VIRGINIA ELECTRIC AND POWER COMPANY
RICHMOND, VIRGINIA 23261

AMENDMENT TO OPERATING LICENSE DPR-32 AND RELOAD INFORMATION
FOR CYCLE 7, SURRY POWER STATION UNIT NO. 1
PROPOSED TECHNICAL SPECIFICATION CHANGE

PROPOSED TECHNICAL SPECIFICATION CHANGE

FIGURE 3.12-1A CONTROL BANK INSERTION LIMITS FOR 3-LOOP
NORMAL OPERATION-UNIT 1

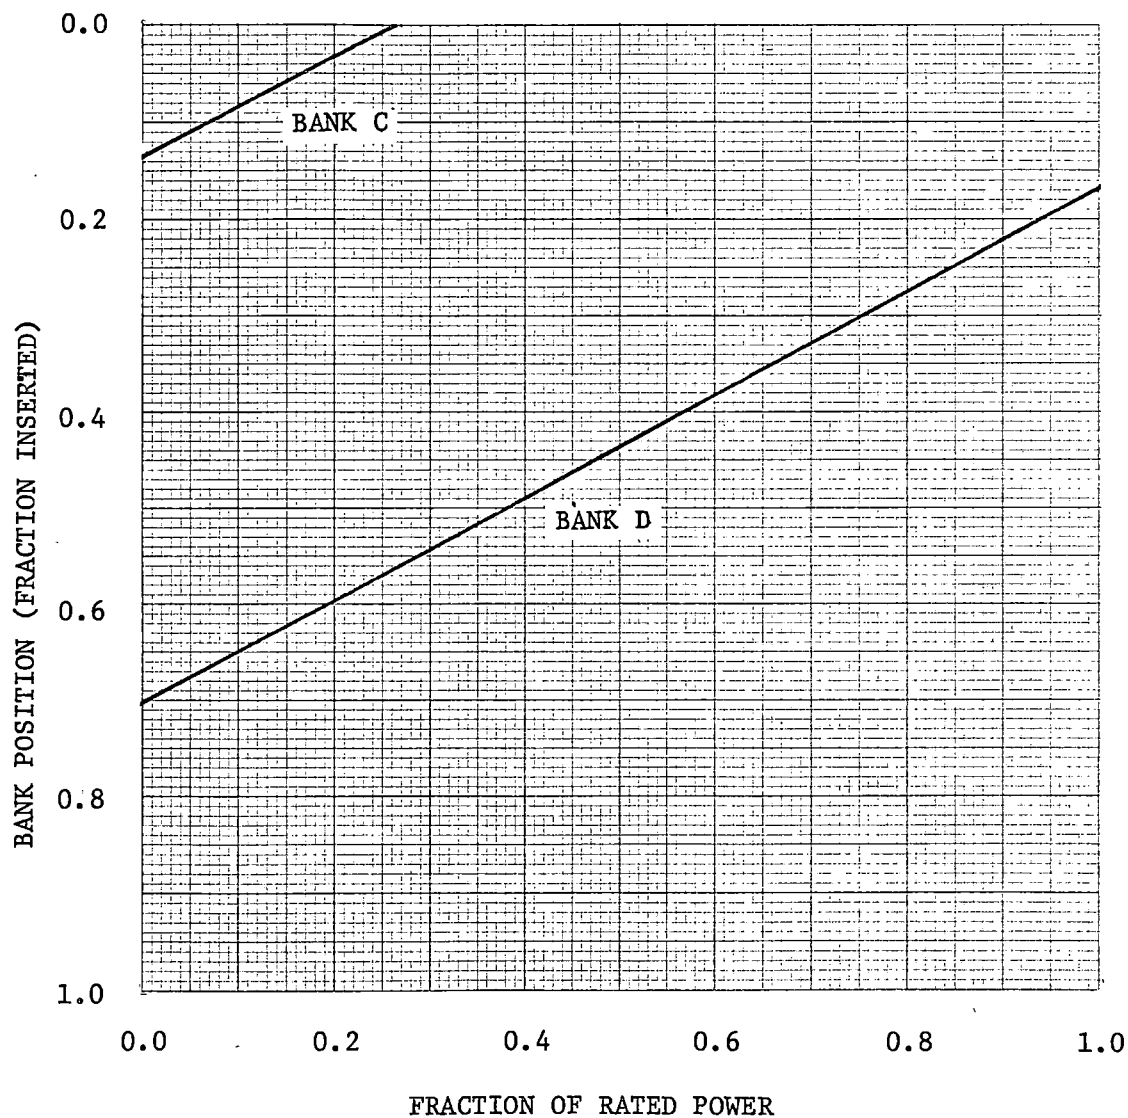
The reload safety evaluation provided is based on analysis performed by Westinghouse in accordance with the methodology documented in Westinghouse Topical Report WCAP-9272. The results indicated that no key analysis parameters would become more limiting during Cycle 7 operation than the values assumed in the currently applicable safety analysis. The bases of this evaluation include the assumption of a revision to the presently approved control rod insertion limits. The revised insertion limits are required to meet the current radial power peaking factor design limits for Cycle 7 operation. Therefore, Vepco proposes to raise the rod insertion limits for Surry Unit 1, via a change to the Technical Specifications provided in Attachment 1.
